NOTICE OF PUBLIC HEARING
GLENPOOL PLANNING COMMISSION

MINUTES OF PUBLIC HEARING
GLENPOOL PLANNING COMMISSION

RE: LOT SPLIT: GLS-#205 "STARBUCKS COFFEE SHOP"

RE: SITE PLAN FOR 2014-04 "STARBUCKS"

SITE PLAN
SHEET NO.
C6

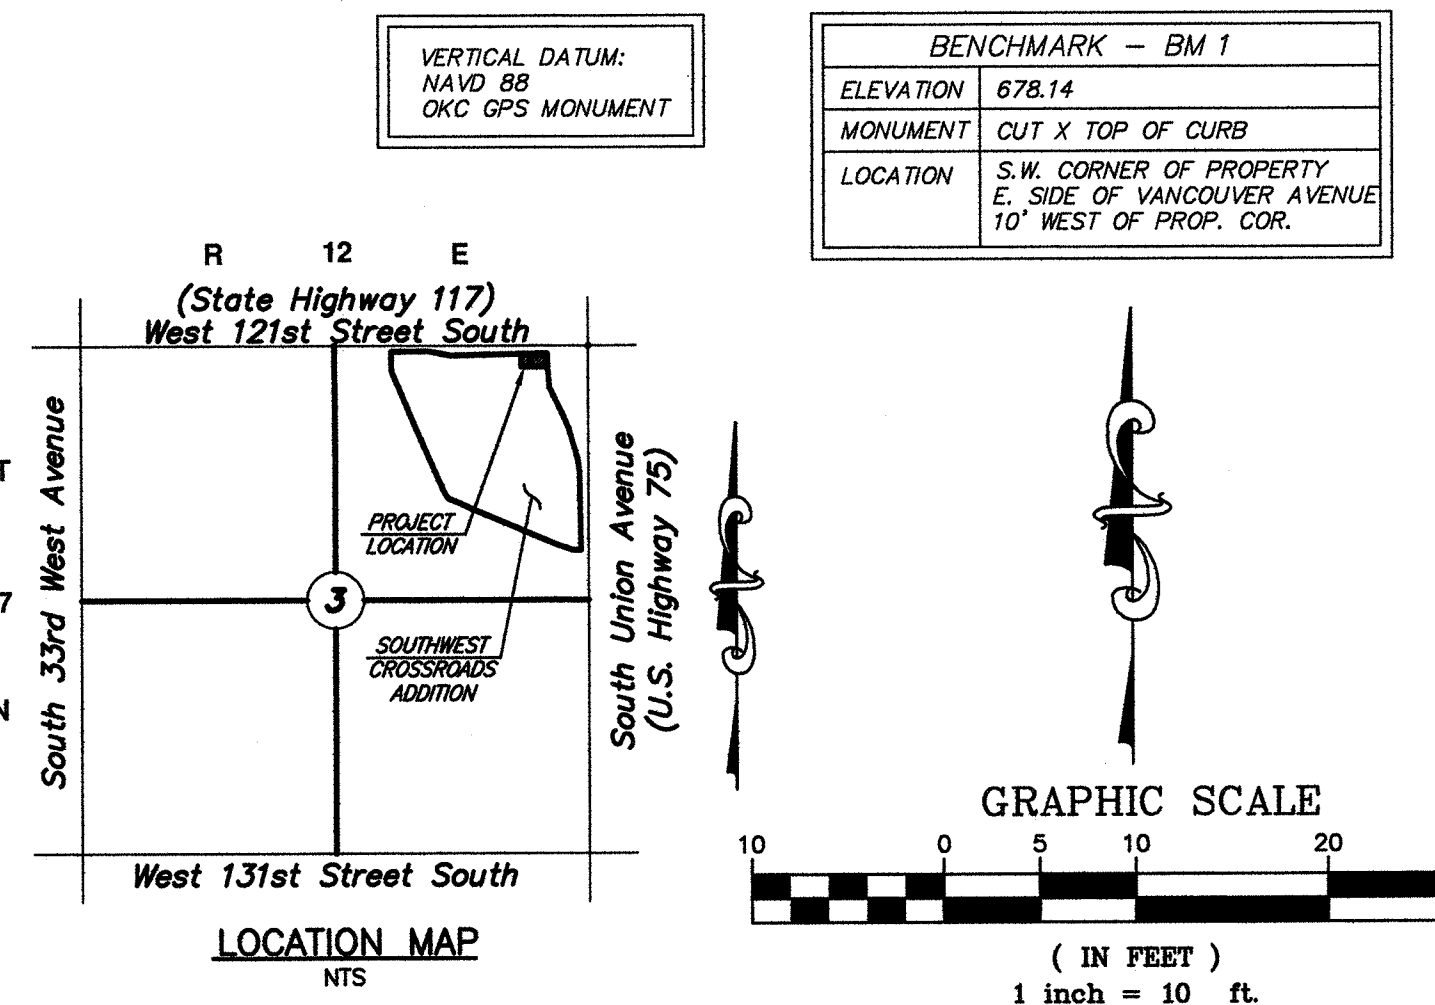
- *The staff has reviewed the parking provisions of the site plan and found that they comply with regulations. Glenpool's zoning code requires 1 parking space for every 200 square feet of floor area. In short, this plan would require a minimum of 9 spaces with 1 space being handicap accessible according to the regulations. The site plan provides for 26 parking spaces with 2 handicap accessible spaces.*

- *The staff has also reviewed the landscape provisions of the site plan and found that they exceed the minimum standards. (see attached landscape plan and details)*

- *The sanitary sewer will need to be extended to serve this site and corresponding utility easement. A performance bond can be issued to the City of Glenpool for this work and an ODEQ permit is required before acceptance.*

- *An Earth Change permit will be required.*
- *A sidewalk will need to be added to the west side of the lots the full length of S. Vancouver Ave with ramps meeting City of Glenpool Development and ADA standards before a certificate of occupancy will be issued.*

UTILITY PLAN

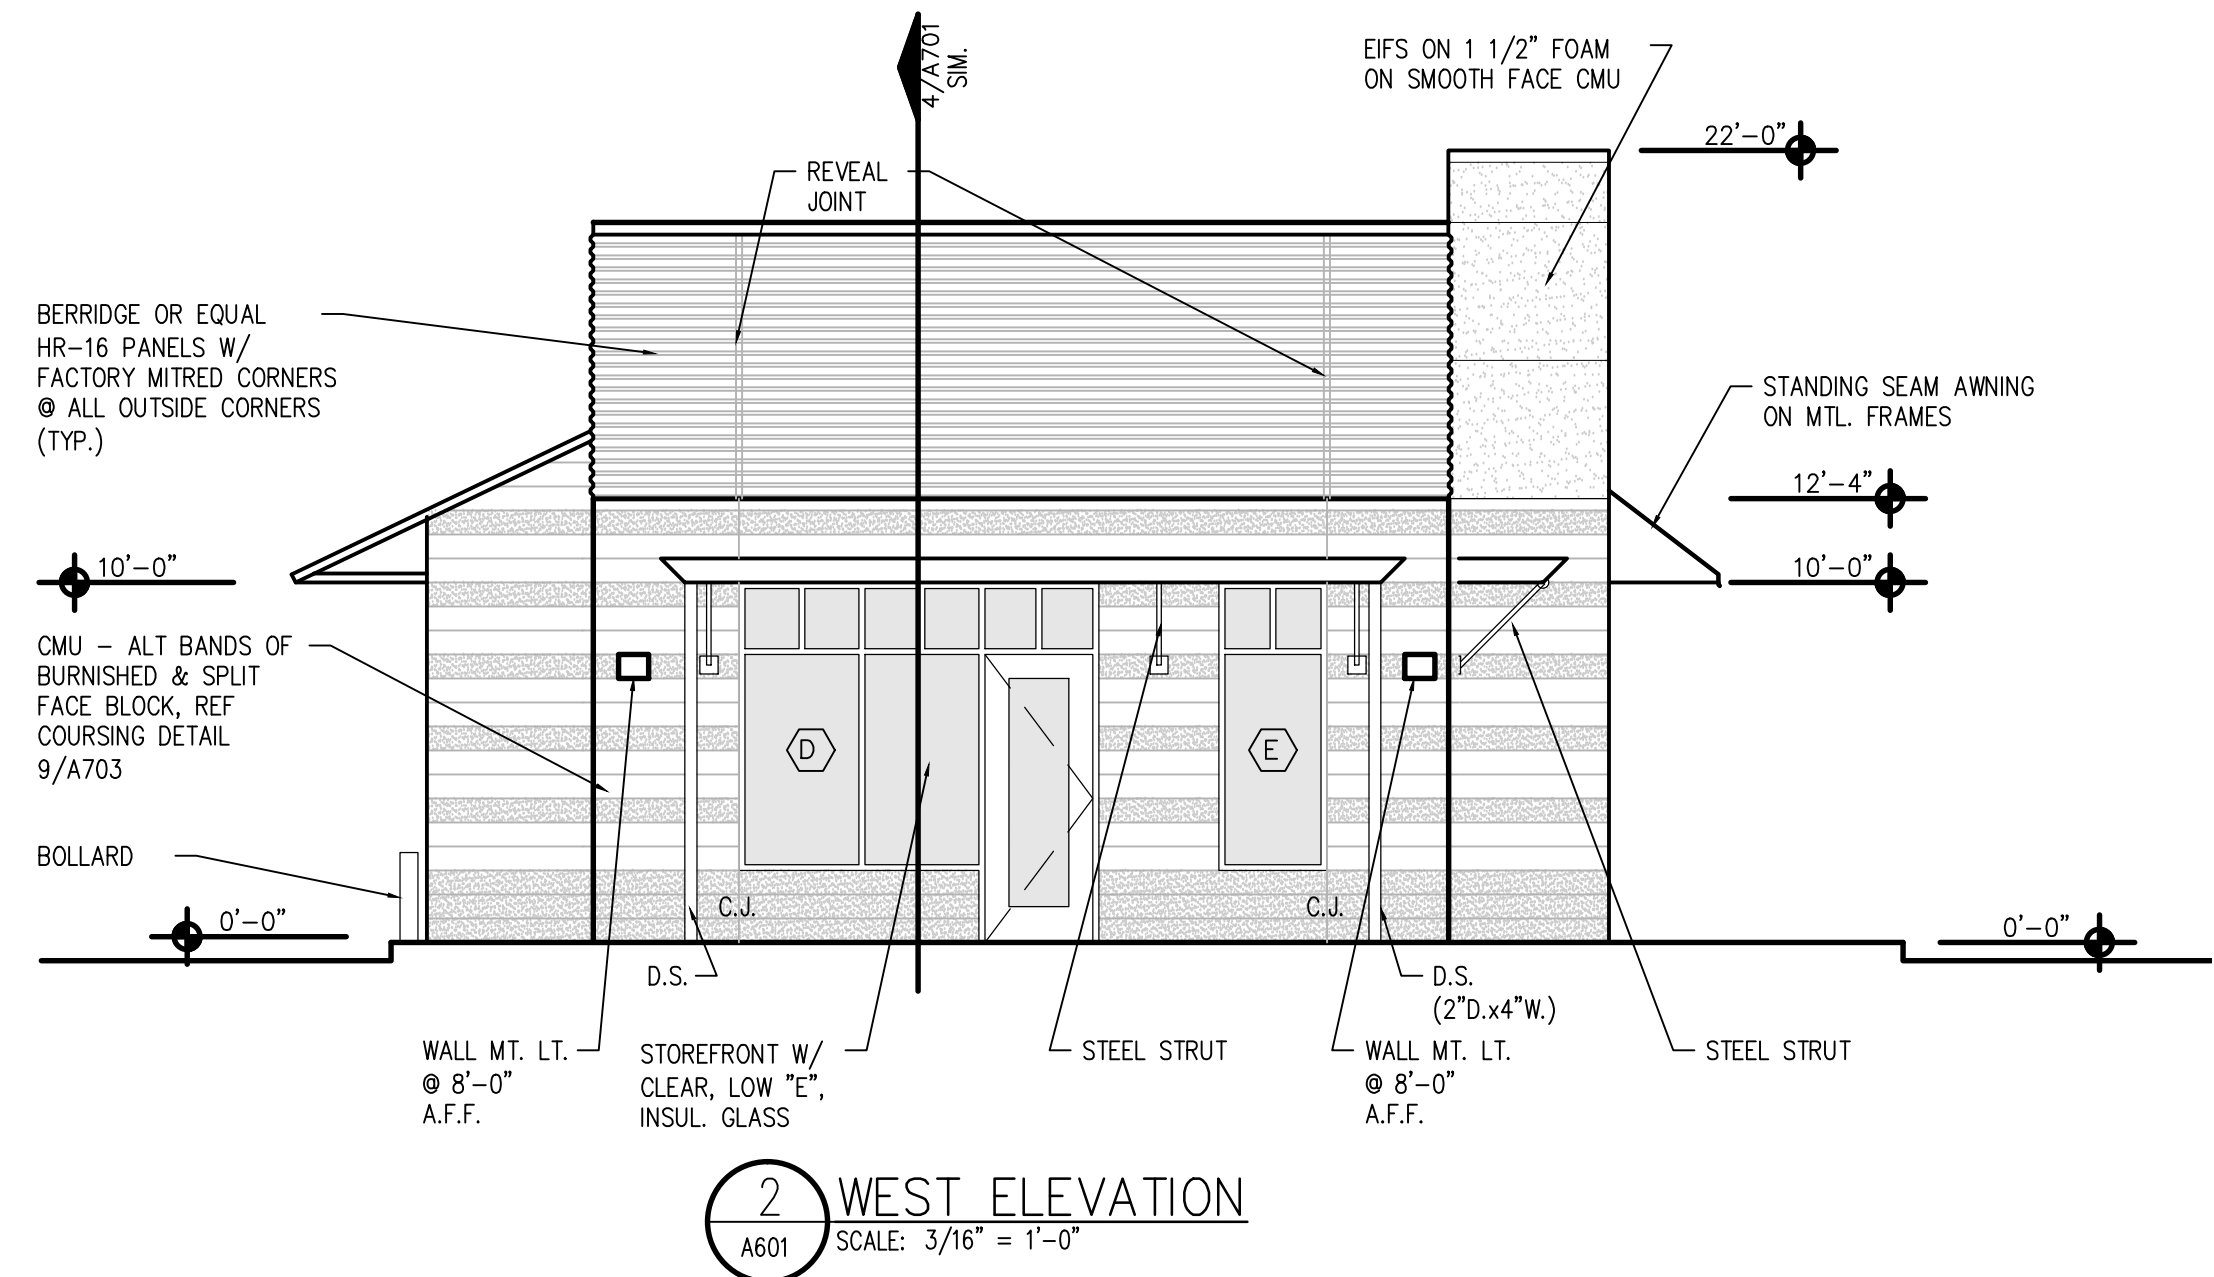
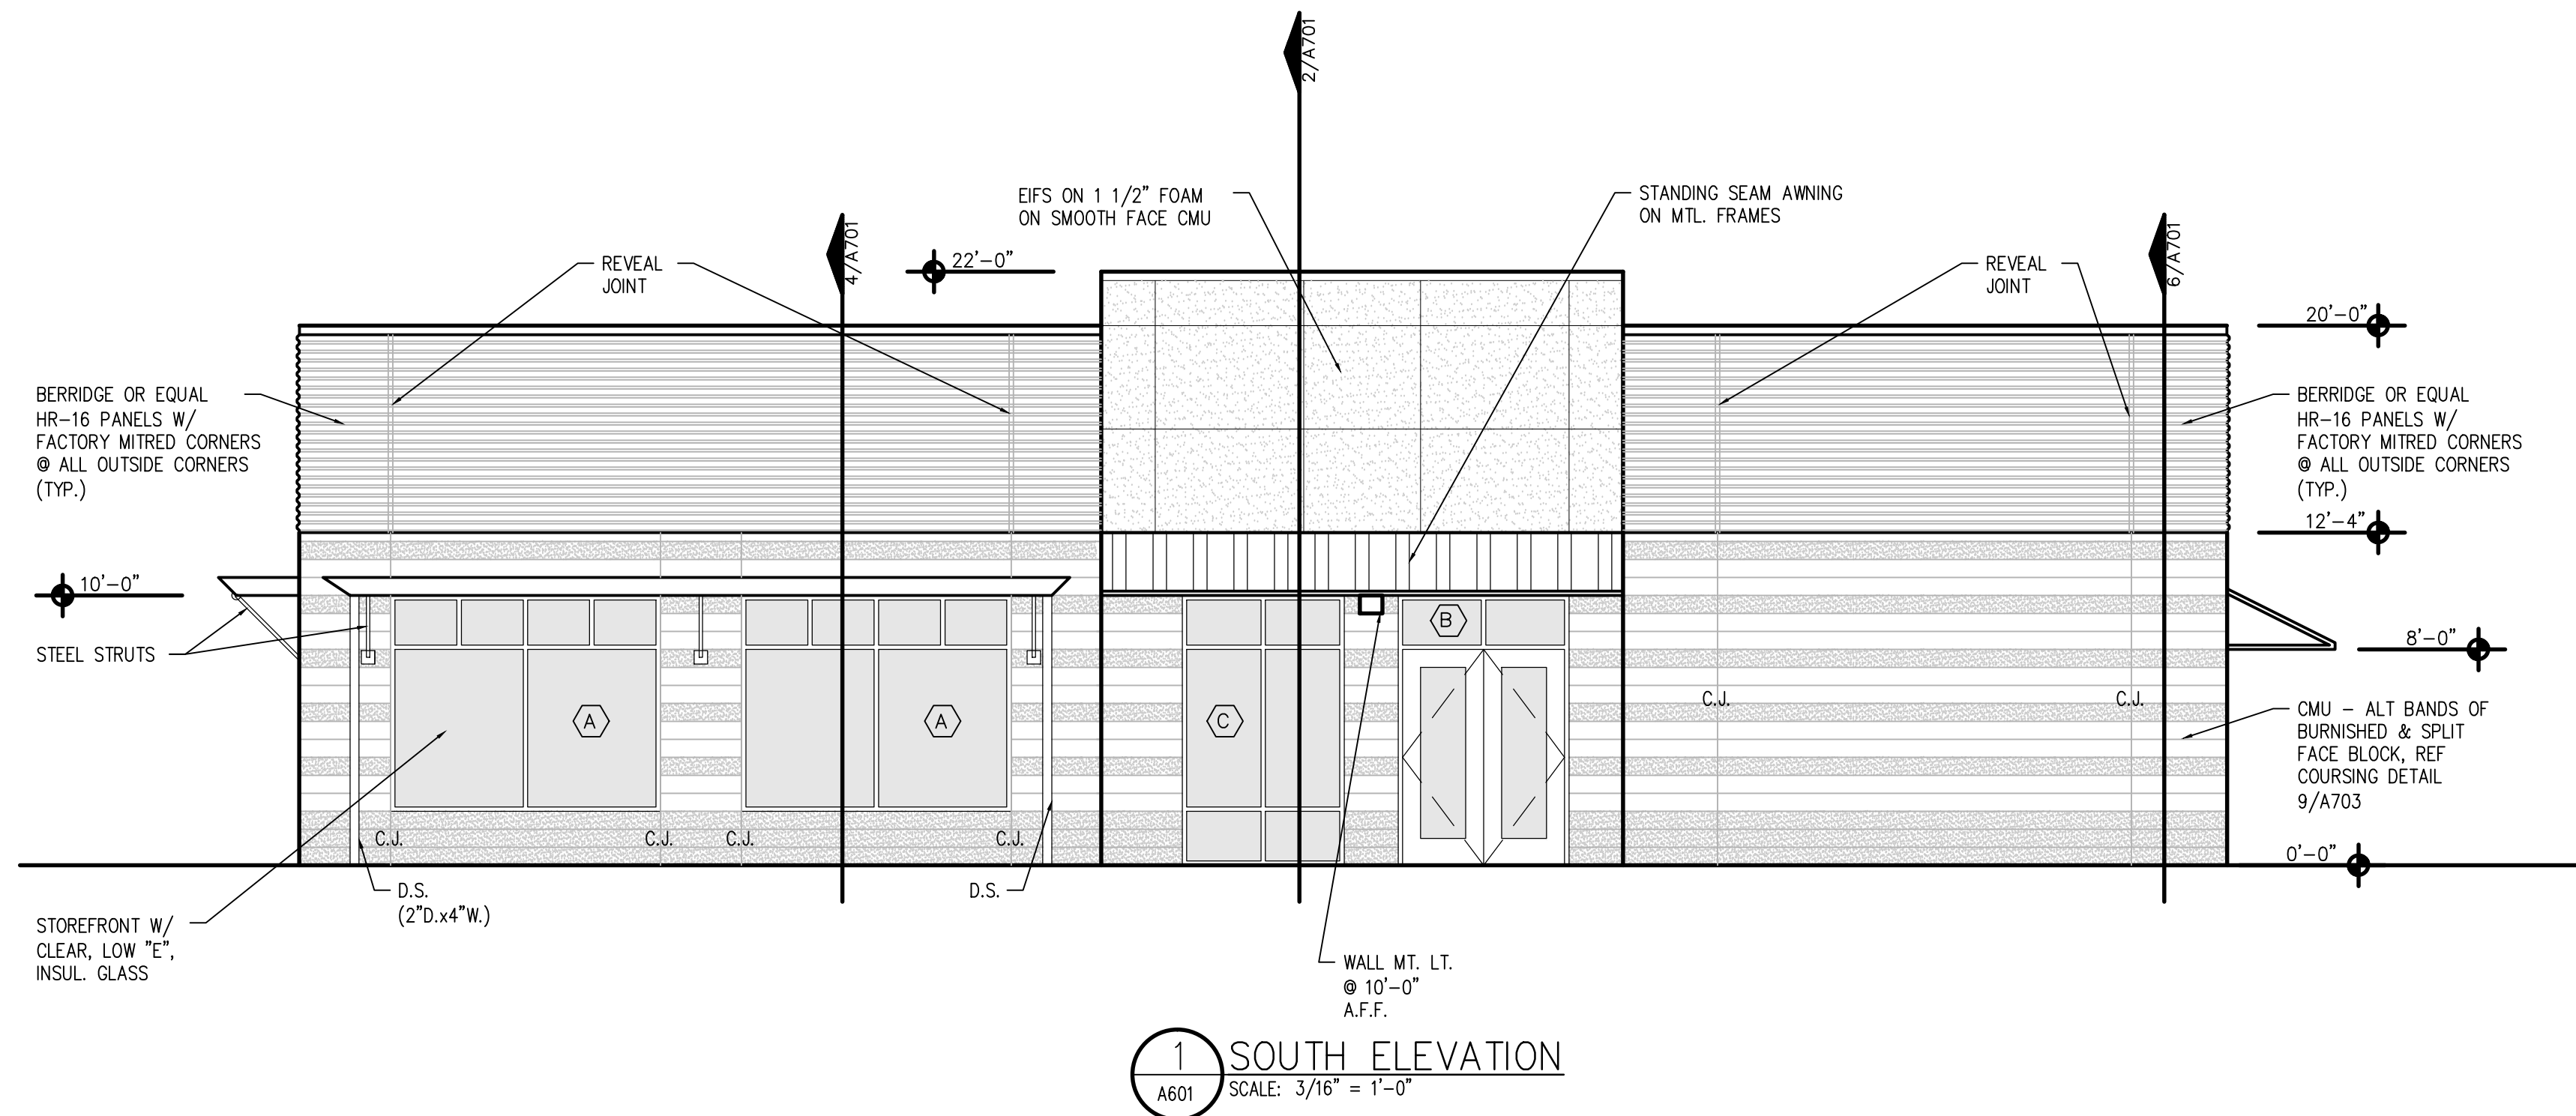
- *The utility plans were reviewed at the TAC meeting and with the exception of the sanitary sewer needing to be extended to this site; all necessary utilities and easements are adequate to service this site.*
